JAMES A. FITZPATRICK NUCLEAR POWER PLANT

Amendment No. 111
License No. DPR-59

ATTACHMENT TO LICENSE AMENDMENT NO. 111

SAFETY EVALUATION BY THE OFFICE OF NUCLEAR REACTOR REGULATION
RELATED TO AMENDMENT NO. 111 TO FACILITY OPERATING LICENSE NO. DPR-59
POWER AUTHORITY OF THE STATE OF NEW YORK
JAMES A. FITZPATRICK NUCLEAR POWER PLANT
DOCKET NO. 50-333

FIGURE 6.2-1

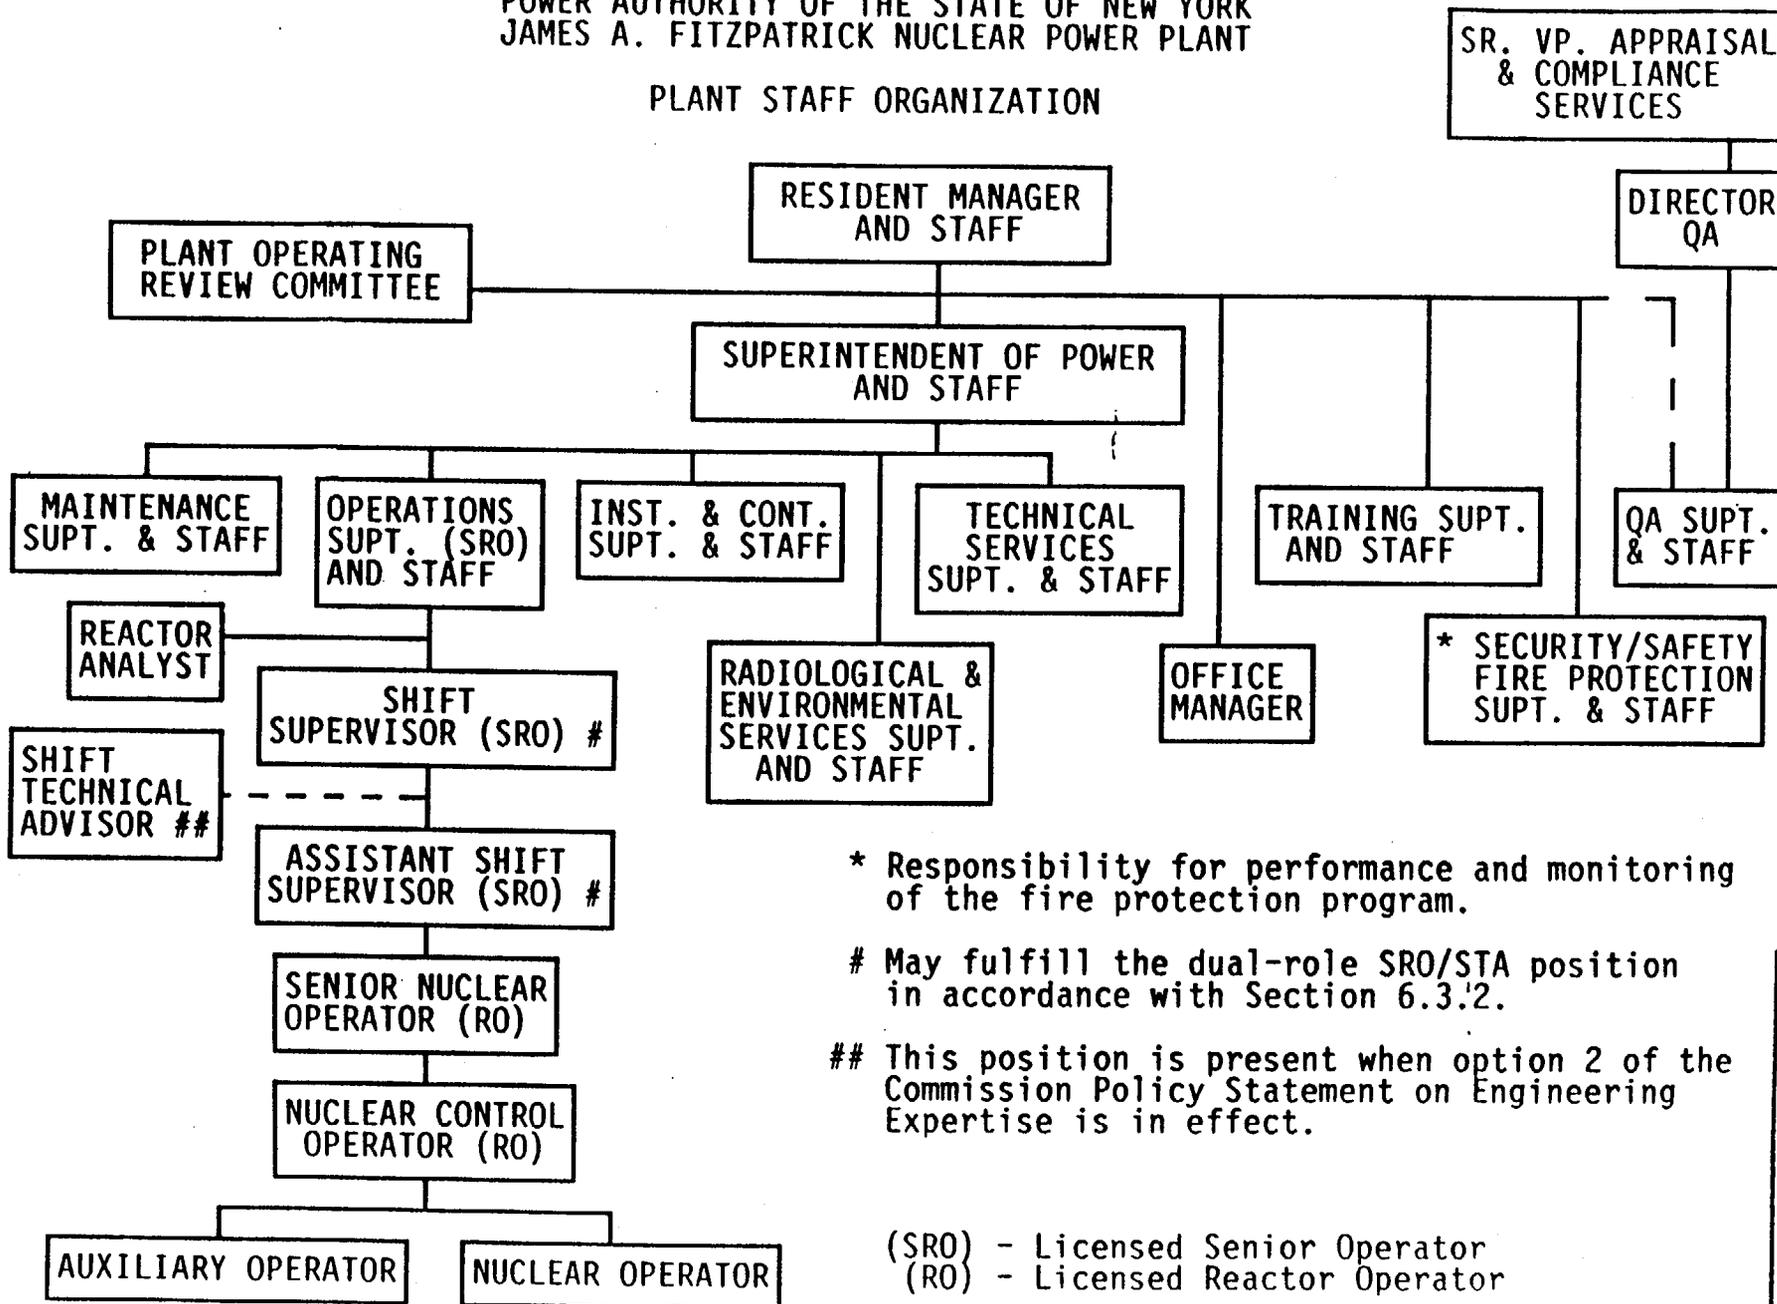
Figure 6.2-1 has been revised to add a second SRO (Assistant Shift Supervisor) to the shift staff in order to incorporate previous licensee commitments to meet NUREG-0737 requirements. In addition, two notes have been included in Figure 6.2-1. The one pound sign indicates that either the Shift Supervisor or Assistant Shift Supervisor may be a dual-role SRO/STA in accordance with Section 6.3.2. The two pound sign indicates that the STA position is present only when option 2 of the Commission Policy Statement on Engineering Expertise on Shift is in effect.

These revisions are acceptable for they reflect the changes described and accepted in Section 6.2 and Section 6.3 of this Safety Evaluation.
